Commission Agenda Report

Planning Commission Meeting
10-05-26
Item 5.C.

Subject: Coastal Development Permit No. 23-010 and Tentative Parcel Map No. 23-001 – An application for a two-unit housing development and urban lot split under Senate Bill 9

Location: 28809 Boniface Drive, not located within the appealable coastal zone
APN: 4466-018-025
Owner: Donald R. Lehman and Marie Christine Lehman Trust

Figure 2 – VHFHSZ Map

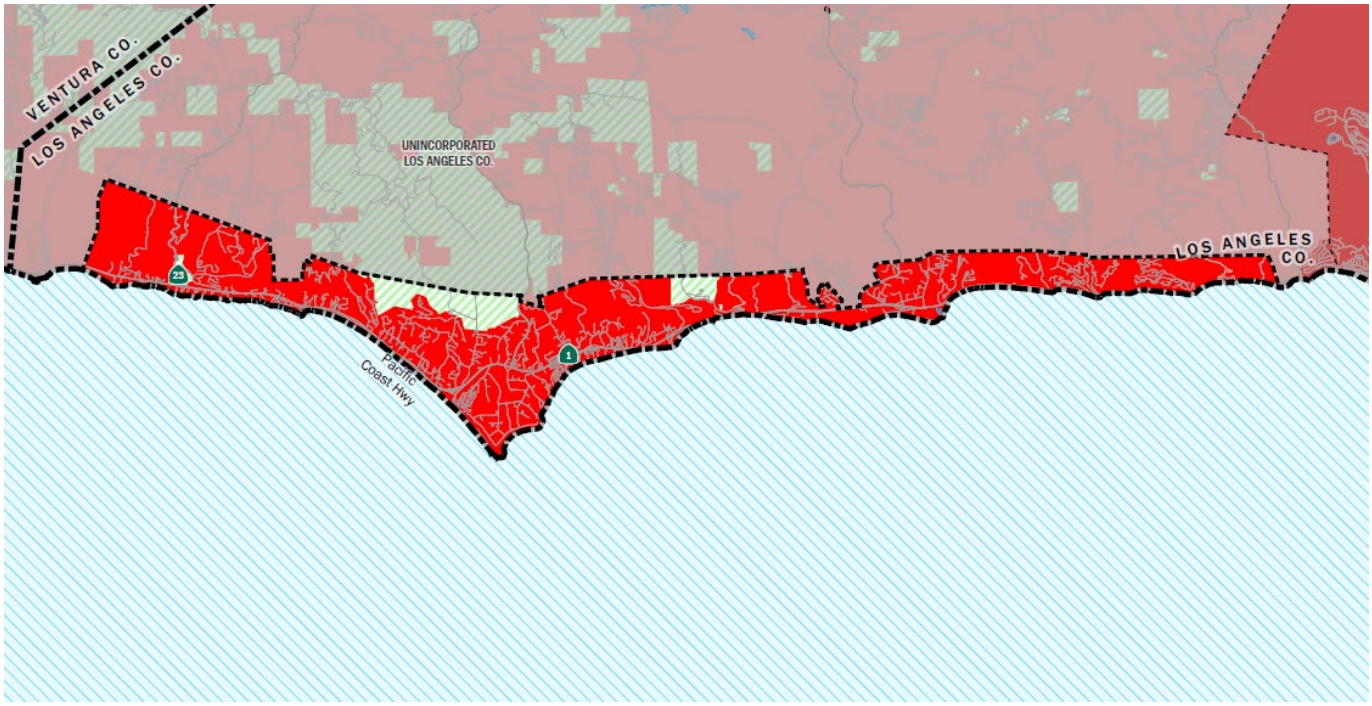
Figure 2, as adopted by the City Council, illustrates that all of Malibu is within a VHFHSZ (indicated in red). The Federal Responsibility Area is shown in hatched green.

Multiple provisions of the certified LCP require new development, which includes a land division, to minimize risks to life and property in areas of high fire hazard. The subject parcel is within the VHFHSZ (Figure 2). Coastal Act section 30253(a) provides that new development shall "minimize risks to life and property in areas of high geologic, flood, and fire hazard," and LUP Policies 4.2 and 4.45 carry that requirement into the certified LCP for new development and land divisions in fire hazard areas. LIP Section 7.1 identifies increased risk to life and property from fire as a cumulative effect of new parcels. LIP Chapter 9 designates the VHFHSZ as a hazard area subject to those policies (LIP Sections 9.1, 9.2(A)(7)). For land divisions, LIP Section 15.2(B)(1)(b) requires a finding that each proposed parcel has an identified building site that is safe from extreme fire hazard and a safe access road that complies with fire safety regulations. LIP Section 9.4(O) prohibits land divisions unless all proposed parcels can be demonstrated to be safe from flooding, erosion, geologic and extreme fire hazards.

Figure 4 – Proposed Site Plan and Parcel Configuration

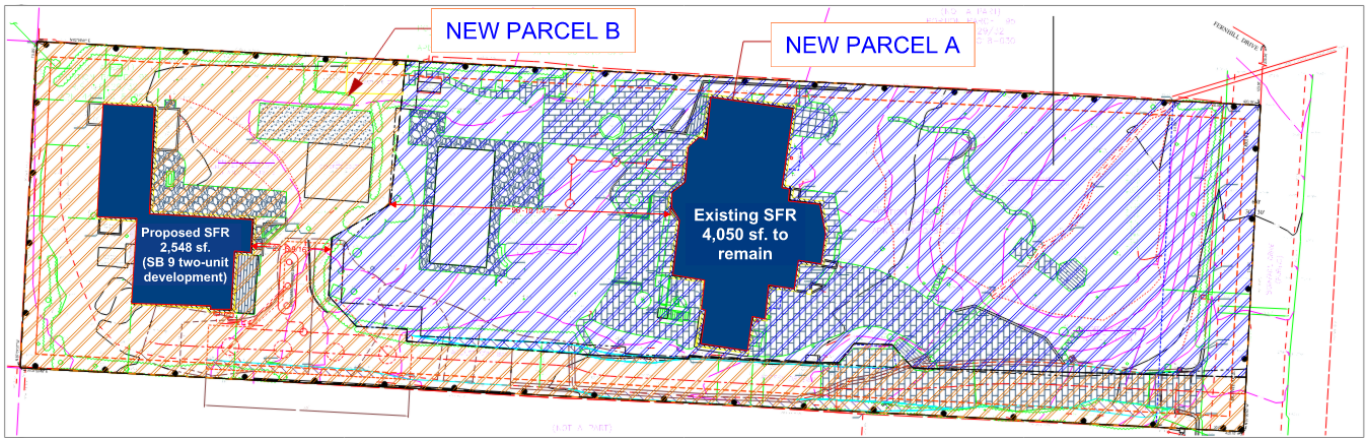
a. Urban lot split according to SB 9 standards to subdivide the subject parcel into (Figure 4):
    i. Parcel A (proposed front parcel with a lot size of 25,536 sf. and existing single-family residence that would remain as is)
    ii. Parcel B (proposed rear parcel with a lot size of 18,100 sf. and proposed single-family residence)
b. Access to Parcel B from Boniface Drive by a 15 ft. wide strip held in fee and reciprocal access easements.

Figure 5 – Existing Floor Plans Showing Demolition

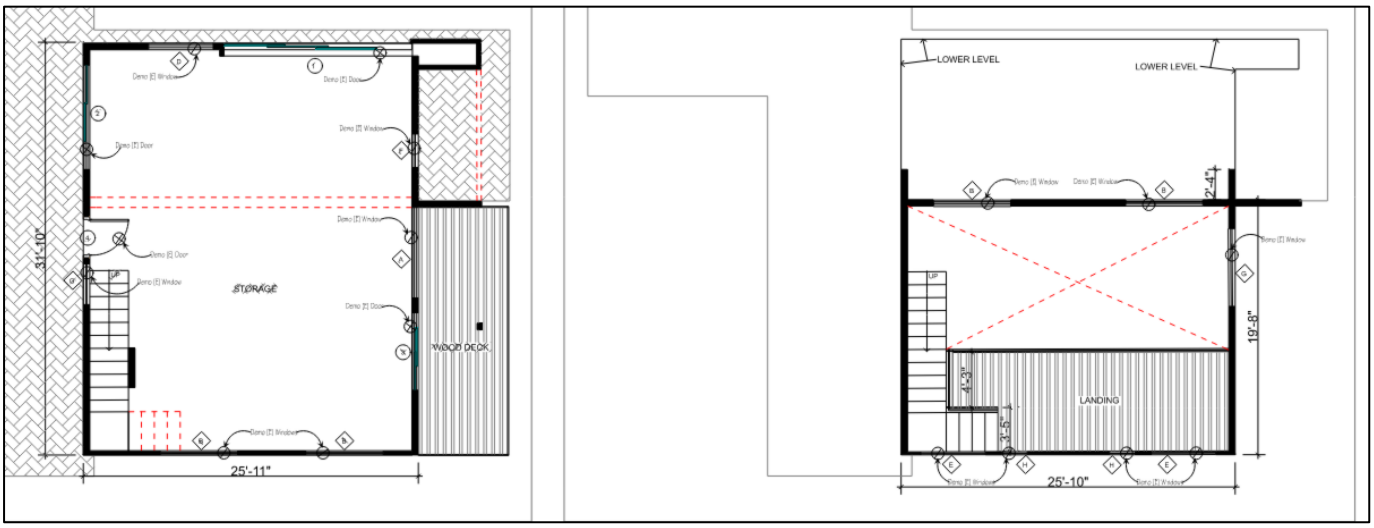
As shown in Figure 5, the walls of the storage building's first floor (left) and the second floor (right) in solid black are indicated for demolition on the project plans (Attachment 2). The remainder of the perimeter consists of window and door systems.

The applicant characterizes the proposed residence (associated with the non-habitable storage building) as an existing 21 ft., 8 in. structure approved under SPR No. 12-027 and "converted" without any increase in height. However, as represented on the project plans, the ground floor of the non-habitable storage building would be enlarged from 832 sf. to 2,000 sf., converted into a dwelling unit, and all of its exterior walls would be removed

(Figure 5). Moreover, the 2012 approvals authorized a *non*-habitable storage building only and did not authorize any conversion into habitable use. A change to habitable use is itself *development* under the LCP because it would change the intensity of use of land.[19] It must comply with the LIP and LCP today.
